Alabama State Port Authority
Addendum to R&P or Specification Booklet

Project Name Hi-rail boom truck

ADDENDUM #1

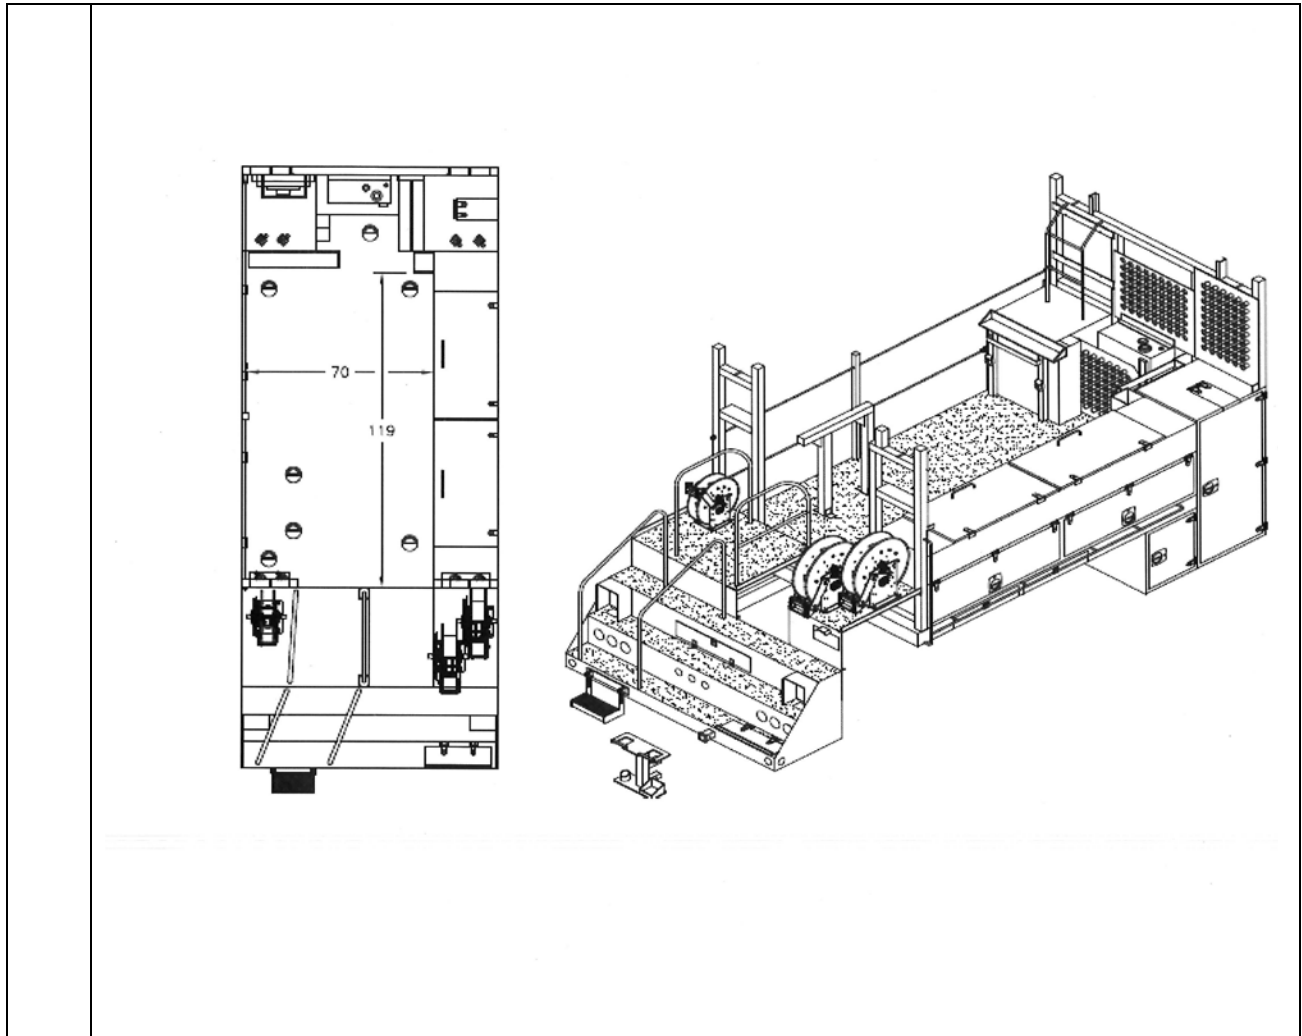
Item	Description
1.	<p>Bid description is changed to read as follows:</p> <p>The Alabama State Port Authority Terminal Railway will be accepting sealed bids until Jan. 14th 2020 at 10a.m. to furnish one new Freightliner 108SD or equivalent Tandem Axle Hi-Rail Gang 4 door truck with crane, tool attachments and boxes. See attached Spec sheet.</p> <p>The first bullet point of the Chassis Specifications is changed to read as follows:</p>
2.	<ul style="list-style-type: none">• Freightliner 108SD or equivalent.
3.	<p>The following bullet points are added to the specifications:</p> <ul style="list-style-type: none">• Automatic transmission or ultrashift• Front aluminum wheels• Power mirrors
4.	<ul style="list-style-type: none">• Air ride driver seat <p>The image below is a representation of the desired bed layout.</p>
